Proposal for Supplement 10 to the 04 series of amendments to Regulation No. 44 (Child Restraint Systems)

The text reproduced below was prepared by the expert from Spain on behalf of the Technical Services Group (TSG) on Regulation No. 44. The modifications to the current text of Regulation are marked in bold for new or strikethrough for deleted characters.

Figure 1
Procedure type 1

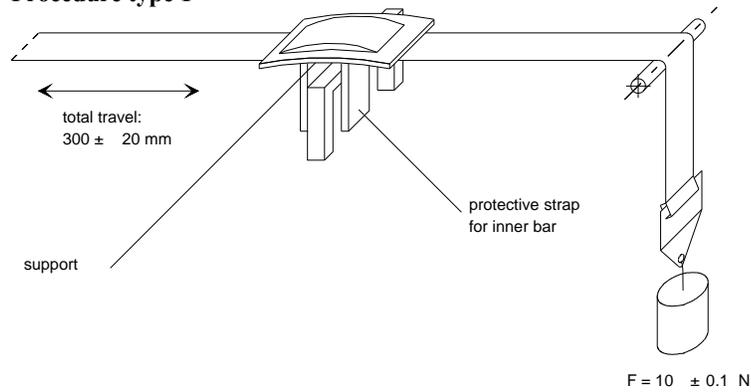
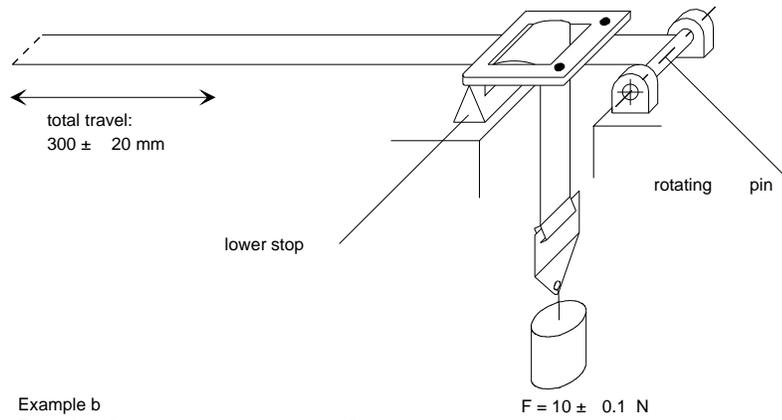
8.2.5.2.6.3.1. Type 1 procedure: for cases where the strap slides through the quick adjusting device. **Apply a load of 10 N, if necessary the load may be increased by 10 N steps so as to permit correct sliding, but limited to a maximum of 60 N. This** ~~The 10 N~~ load shall be vertically and permanently applied on ~~one of~~ the straps. ~~The other part of the strap set horizontally shall pass through the quick adjuster it is fitted to and~~ shall be attached to a device, giving the webbing a back and forth motion. ~~The quick adjusting device shall be so placed that the horizontal strap of the webbing remains under tension (see Annex 5, Figure 1). Activate the quick adjuster while pulling the straps in the direction to slacken the harness and deactivate it while pulling the straps in the direction to tighten the harness.~~

Remark. $F = 10 \pm 0.1$ N, can be increased up to $F = 60 \pm 0.5$ N

7. Annex 5: Drawing modified to be consistent with new paragraphs 8.2.5.2.6. to 8.2.5.2.6.3.2.

Figure 2
Procedure type 2
Following two examples of test set up;

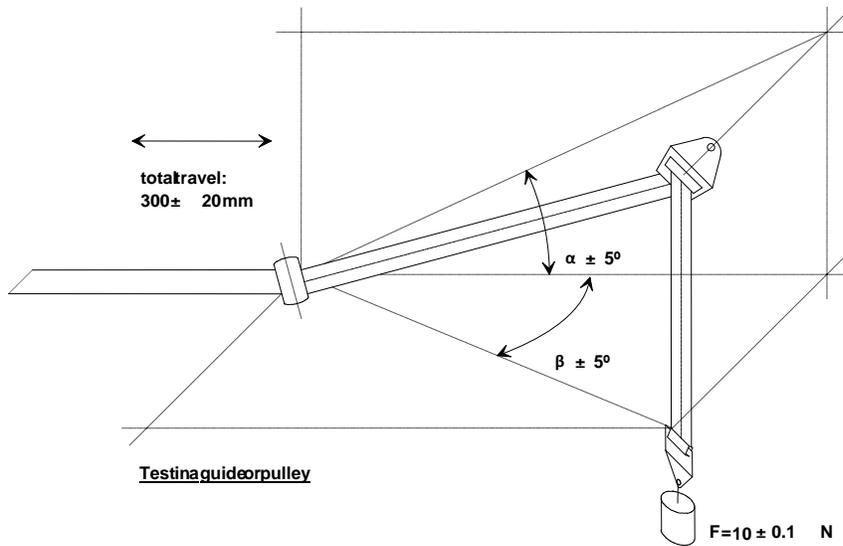
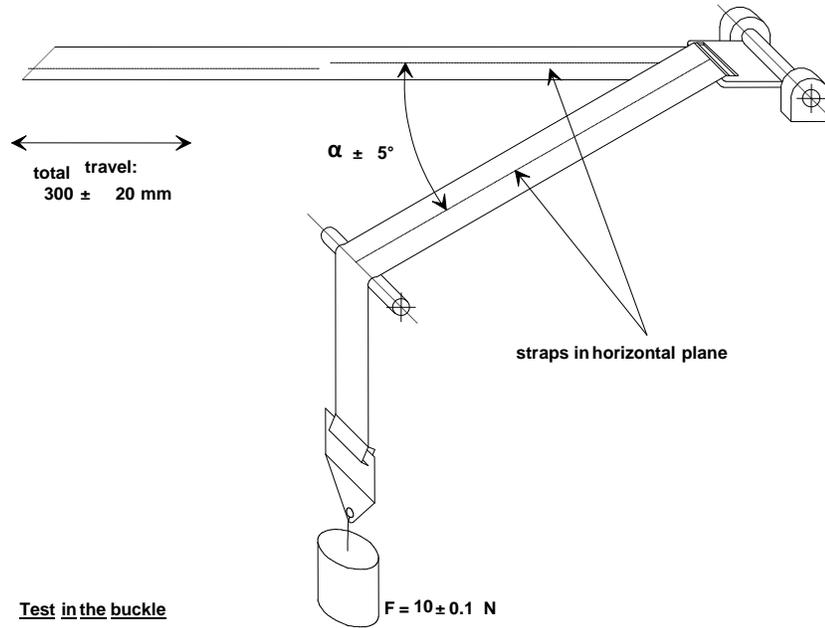
8.2.5.2.6.3.2. Type 2 procedure: for cases where the strap changes direction in passing through a rigid part. During this test, ~~the angles of both~~ webbing straps shall **pass through the rigid part it is intended for and the test set up shall**

reproduce the angles as in the real installation (in three dimensions), see ~~be as shown in~~ Annex 5, Figure 2 for examples. The ~~5~~ **10** N load shall be permanently applied. For cases where the strap changes direction more than once in passing through a rigid part, the load of ~~5~~ **10** N may be increased **by 10 N steps** so as to **permit correct sliding and** achieve the prescribed 300 mm of strap movement through that rigid part."

Where α and β reproduce the angles as in the real installation (in three dimensions).

Figure 1: Examples of completely recessed support leg

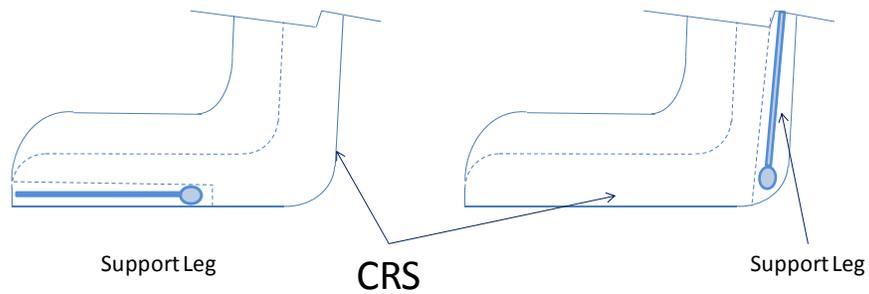
Completely recessed means that when the leg is in its stowed position, no part of the leg protrudes beyond the surface of the base or shell, such that it has no effect on the position of the CRS on the test bench; see also following figures for clarification examples.

4. Paragraph 7.1.4.1.10.1.2. and explanatory note on paragraph 7.1.4.1.10.1.2. under Annex 15: Better definition on how to perform misuse test was needed. Introduced text aims at clarifying how to perform misuse test when a support leg is used.

"7.1.4.1.10.1.2. Without the anti-rotation device in use. **If the anti-rotation device is a support leg and it can be completely recessed within the base or the shell of the CRS the test is conducted with the device in its stowed position or with the leg removed respectively. If it cannot be completely recessed within the base the test is performed with the device deployed in its shortest length with the trolley floor pan in its lowest position.**
